## REQUEST FOR COUNCIL ACTION

ITEM DESCRIPTION: Final Plat #03-10 by Badger Development II, LLC to be known as  
Badger Village TownhomesPREPARED BY:  
Brent Svenby,  
Planner

**RE: Final Plat #03-10 to be known as Badger Village Townhomes by Badger Development II LLC. The Applicant is proposing to re-subdivide Lots 1 & 2, Block 2 Badger Ridge Fourth Subdivision into 37 lots for single-family attached dwellings. The Plat also proposes to dedicate one new public roadway. The property is located west of Superior Drive NW, east of Kenosha Drive NW and north of Monroe Drive NW.**

Final Plat #03-10  
Badger Village Townhomes  
500' Notification Distance  
Ward 3 McConnell  
05/06/03

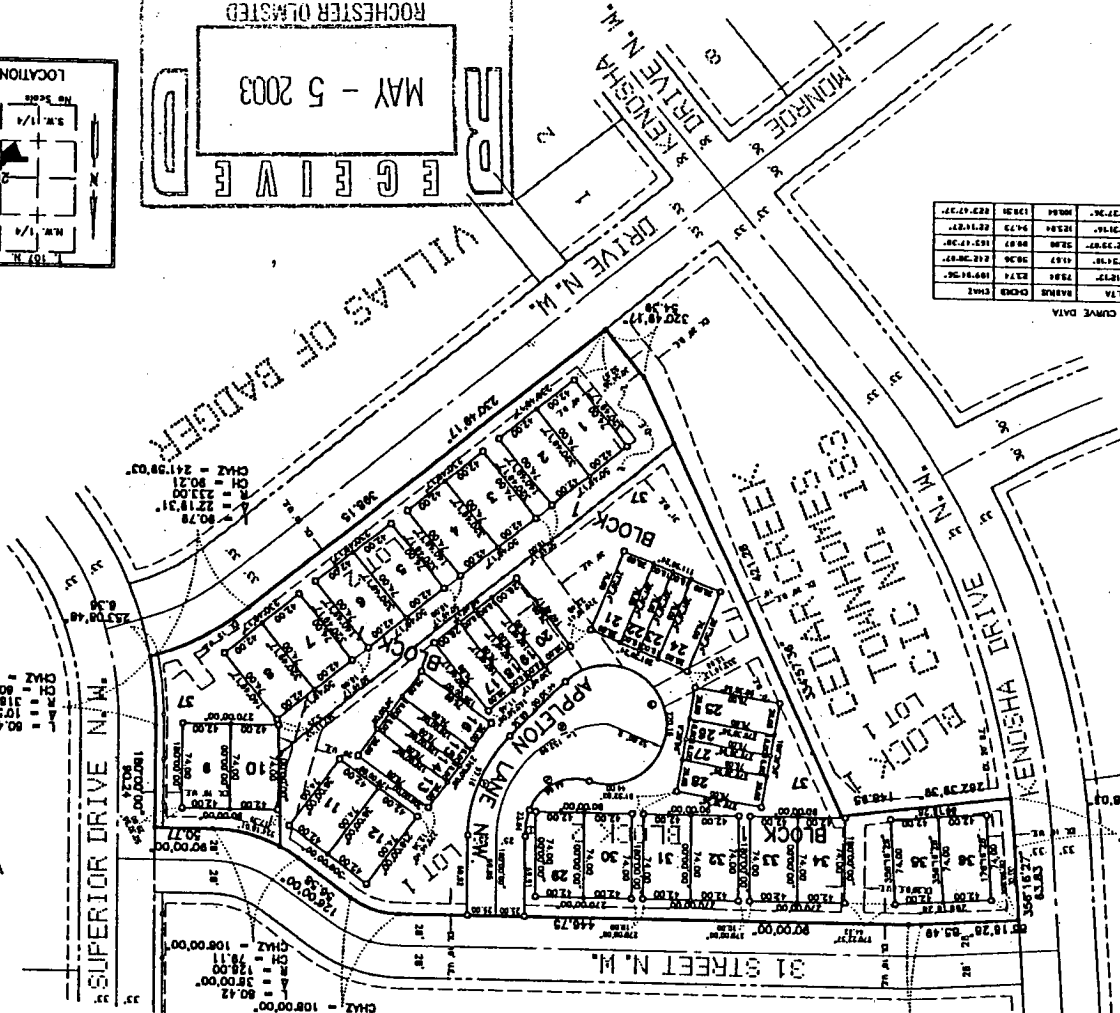
1. *The cul-de-sac associated with this plan is indicated as less than 96 feet in diameter and shall be posted "No Parking" along the cul-de-sac.*
2. *The documents assigning long-term maintenance of common lands and facilities shall be recorded concurrent with the final plat documents (mylars).*
